ZONING BOARD OF APPEALS APPLICATION
TOWN OF SIMSBURY, 933 HOPMEADOW STREET, SIMSBURY, CT 06070

Location of Property: 10 Cedar Glen Road, West Simsbury, CT 06092
(number and street name)

PROPOSED ADDITION
10 CEDAR GLEN
PROPERTY OF
CURTIS LOONEY & MANU SINGH-LOONEY
SIMSBURY, CONNECTICUT

Letter from Architect

PROPOSED ADDITION
10 CEDAR GLEN
PROPERTY OF
CURTIS LOONEY & MANU SINGH-LOONEY
SIMSBURY, CONNECTICUT

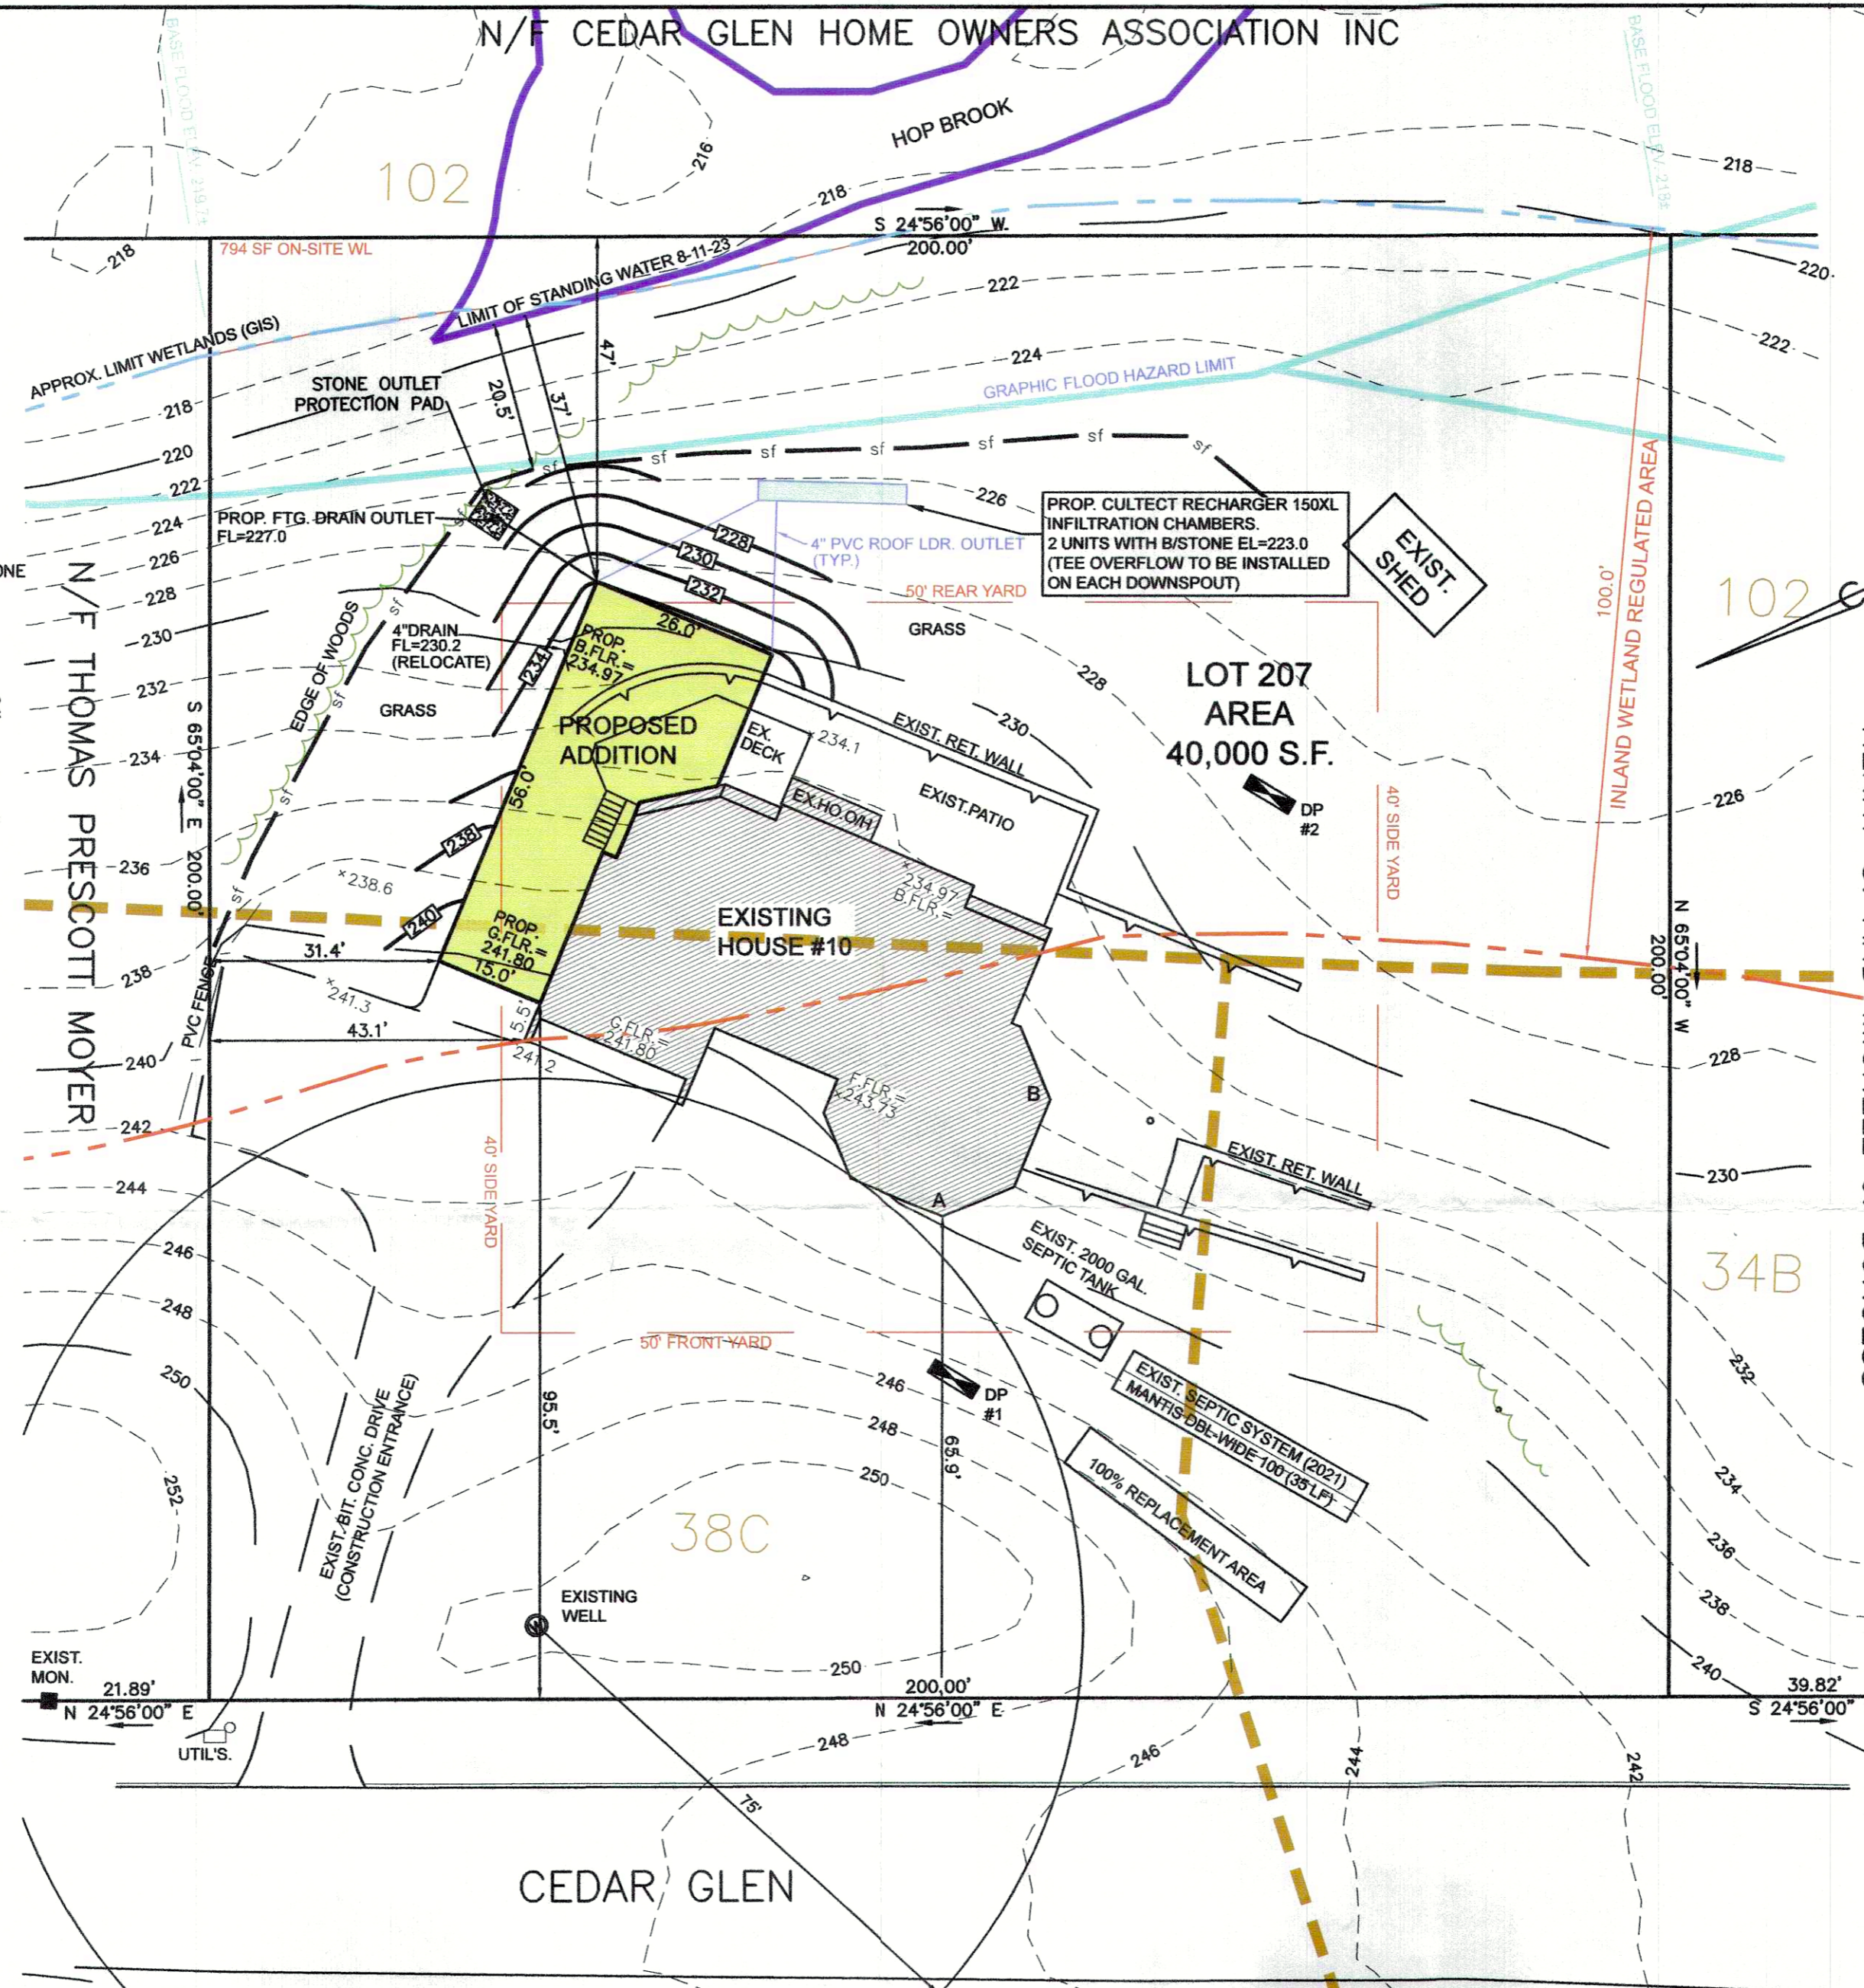
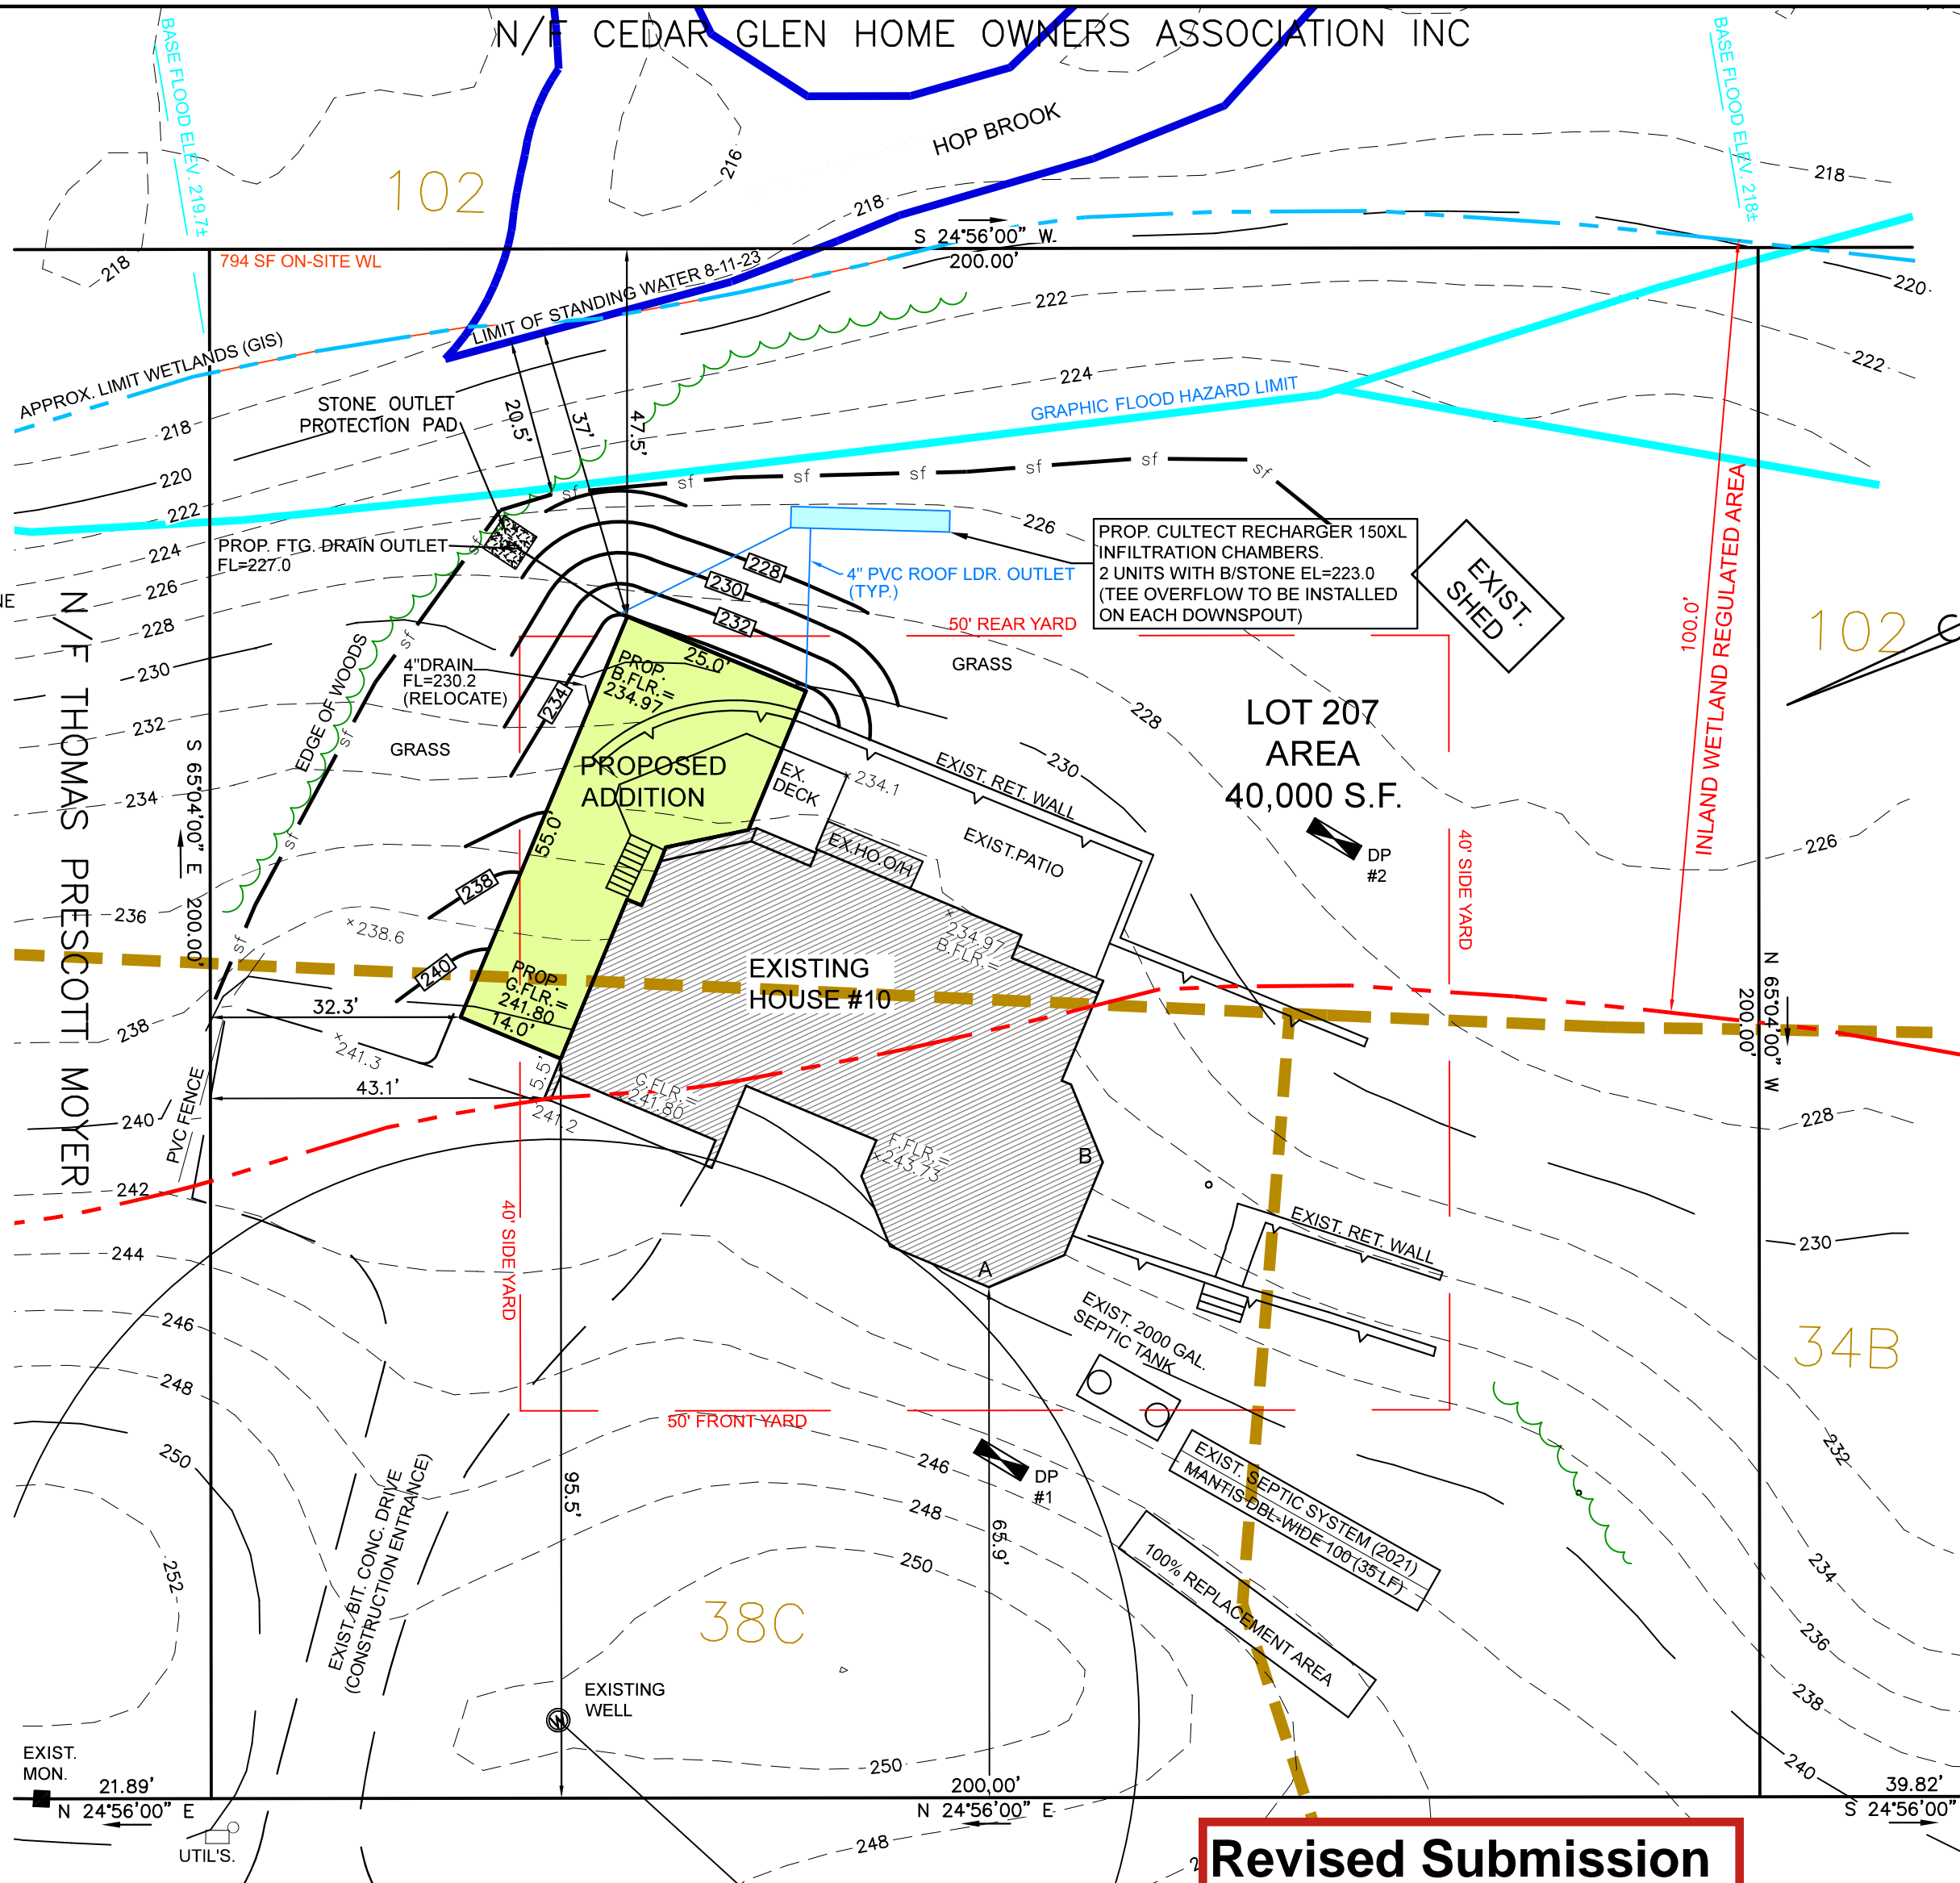
Revised Submission
Setback Changes:
Side 31.4' to 32.3'
Rear 47' to 47.5'
Variance Changes:
Side 8.6' to 7.7'
Rear 3' to 2.5'

REV. 4-22-2024 REDUCE SIZE OF PROPOSED ADDITION
CLARK LAND SURVEYING, LLC
126 TUNXIS ROAD
BRISTOL, CONN. 06010
(860)-967-8590
TODD@CLARKLS.BIZ
DATE: 9-15-2023 SCALE: 1" = 20' MAP NO. 2023-70
